# Response to Comments for Minor Permit AQ1227MSS02

August 18, 2011

This document is the Alaska Department of Environmental Conservation's (Department) analysis and response to the public comments received during the March 11, 2011 through May 11, 2011 public comment period, for Minor Permit AQ1227MSS02. The Department received 780 public comments, from 636 distinct commenters on its preliminary decision to issue Minor Permit AQ1227MSS02 to Usibelli Coal Mine, Inc for the Wishbone Hill Coal Mining and Processing Operation. The Department also received additional comments after this period closed. However, the Department is unable to consider these comments.

# Figure 1 - Wind Rose for 1990 Wishbone Data

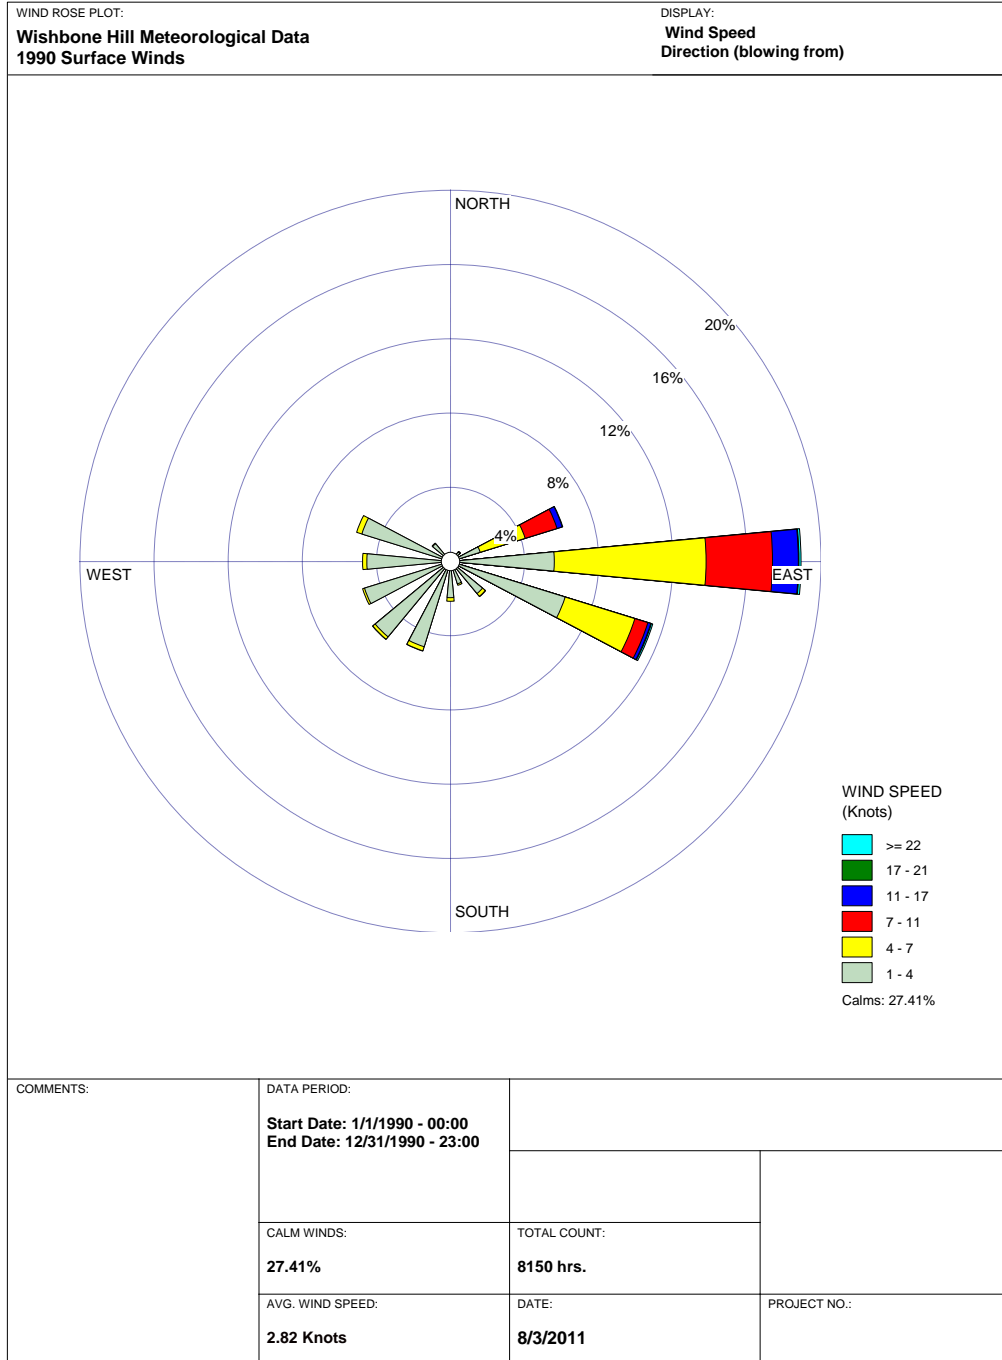
Due to the various stated concerns with Usibelli’s 1990 meteorological data, some commenters recommended the use of meteorological data from other locations. One commenter stated:

“There are several weather stations in the area that have long term data sets, including the Palmer airport, the USGS in Palmer, and numerous personal weather stations found at Weather Underground ([www.wunderground.com](http://www.wunderground.com)), including one at the Sutton airport that is reliable enough to be posted on the Palmer Police department website as a link to local forecasts. Indeed, there are at least 14 weather stations between Palmer and King’s River, with PAJV (Sutton airport) and KAKPALME18 (Moose Range) being the closest to Wishbone Hill...”

*The Palmer NWS airport data cannot be used because it does not represent the wind conditions experienced at Wishbone. This can best be illustrated by comparing the wind roses from both locations (see Figure 1 and Figure 2 below).<sup>3</sup> As illustrated in these figures, the predominate winds at the Palmer airport are from the north, while the predominate winds at Wishbone are from the east. The differences are due to the presence of nearby terrain features (see Figure 3), which channel and direct the surface winds.*

Figure 3 - Topographical Affects on Nearby Winds

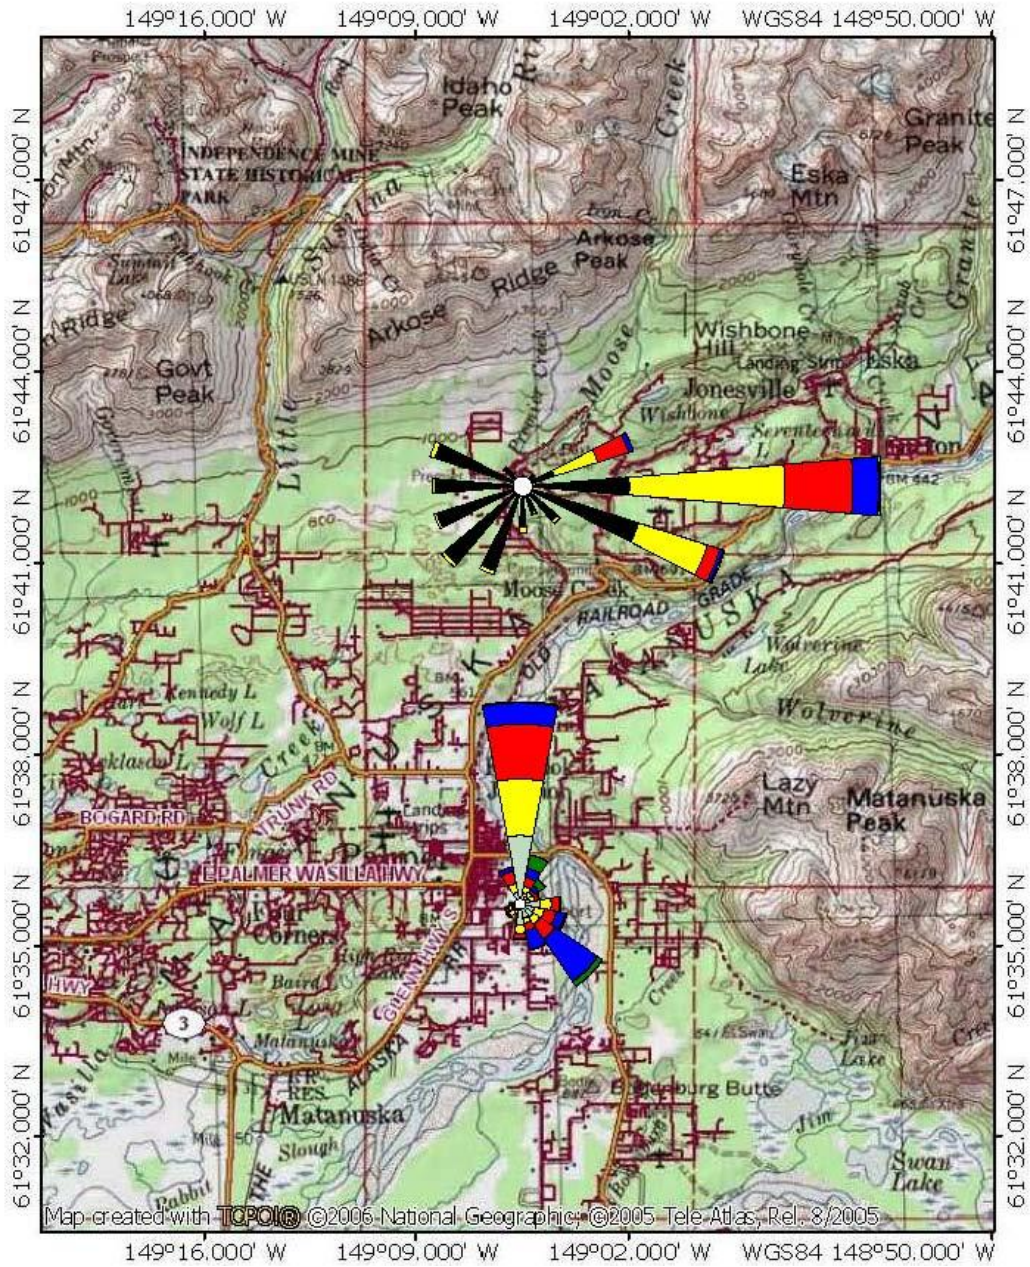
Other commenters stated the exact opposite – that data from other locations should not be used. For example, one commenter stated:

“Using substitute data from Palmer, Anchorage, or other locations in the state is an unacceptable substitute as these areas, due to the geography, are not subject to even similar weather patterns...”
